Product information - BMW brake pads | HELLA

BMW brake pads

8DB 355 009-271 / 8DB 355 015-391

New allocation of the brake pads

8DB 355 009-271 / T1230

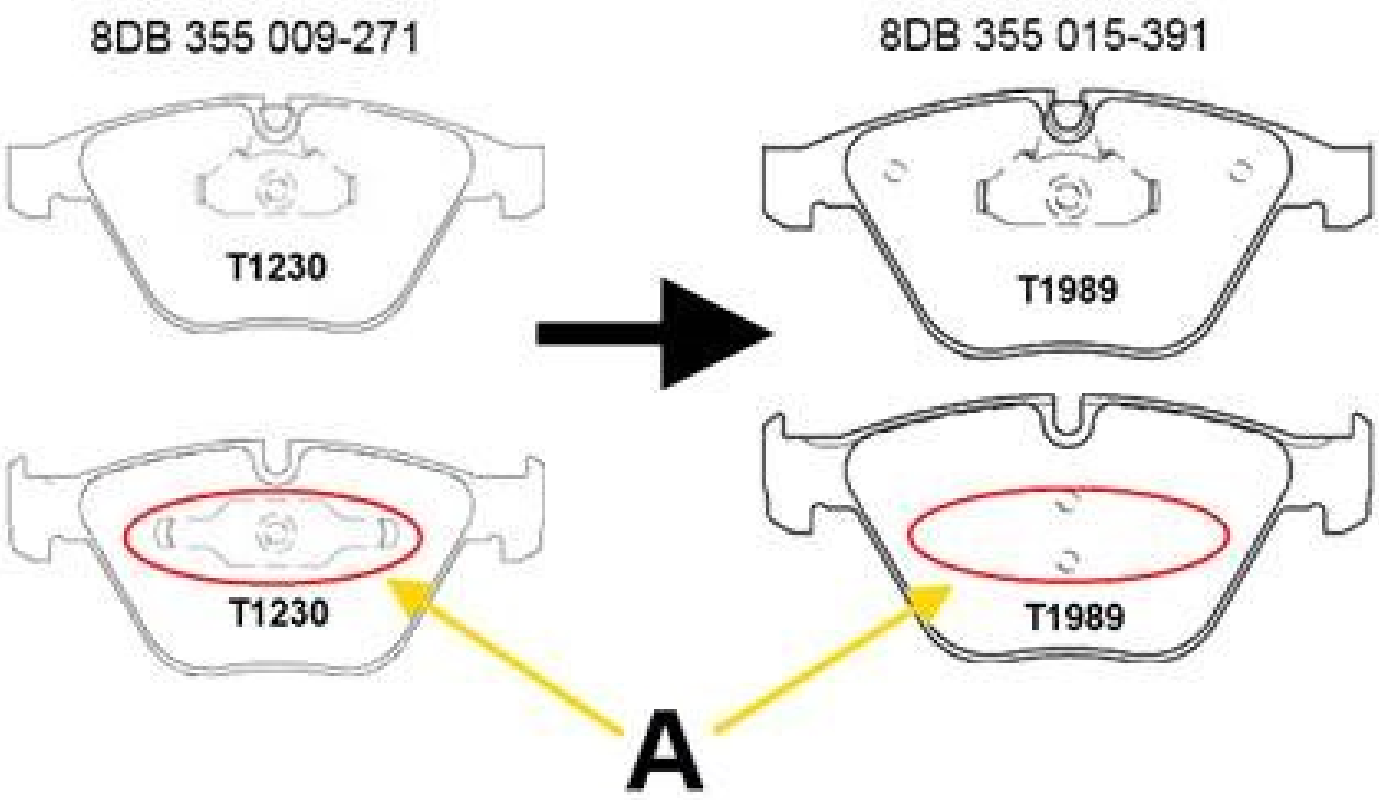
The difference between both brake pads is the missing retaining spring (A) on the brake pad 8DB 355 015-391 / T1989 on the fist side.

Brake pads 8DB 355 009-271 / T1230 shall still be used for the M models of the 1 series (E82) and 3 series (E90-91).

All other models are now covered by 8DB 355 015-391 / T1989. 8DB 355 015-391 / T1989 can also be retroactively used for all vehicles linked.
